Office Action Summary

10/581,325

HAGIST ET AL.

DETAILED ACTION

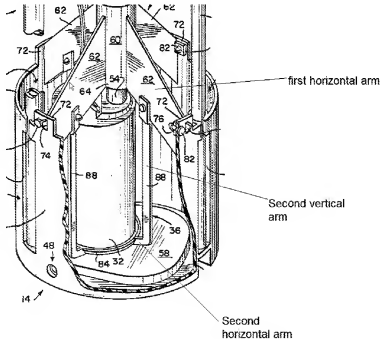
Harris teaches a device for retaining a fuel pump in a fuel container of a motor

vehicle (see figure 1), with a pump holder (including fin members (62) and legs (88)), with first retaining means of the pump holder (the fins (62)), provided for supporting on a baffle pot (the fins are supported on a reservoir cup (30)), and with second retaining means of the pump holder (pump carrier dish(84)), provided for supporting the fuel pump, and with a damping device (the legs (88)) connecting the first and the second retaining means to one another, in that the damping device has arms which are angled away from each other (the legs (88) have a vertical portion and a horizontal portion that is arranged at 90° to the vertical portion. (In addition item 62 which is attached to the horizontal portion of vertical legs 88 can be considered as a horizontal arm), and in that during a movement of the fuel pump the arms are subject to at least a torsional or a bending load (the arms would be subject to any stresses applied to the fuel pump and fuel tank, which includes bending and torsional loads), wherein the arms of the damping device include at least one first vertical arm extending substantially in a vertical direction and first and second horizontal arms extending substantially horizontally and angled away from the first vertical arm (the legs (88) have a vertical portion and a horizontal portion that is arranged at 90° to the vertical portion), the first and second horizontal arms being spaced apart in the vertical direction, and at least one of the first and the second horizontal arms is designed as an annular element (the vertical arms are arranged annularly around the fuel pump), wherein a second vertical arm (one of the vertical arms 88 can be considered second vertical arm) connects the first horizontal arm and the second horizontal arm of the damping device (see annotated drawing) ,and wherein only

the second horizontal arm of the arms of the damping device is directly connected to the second retaining means (see annotated drawing again).
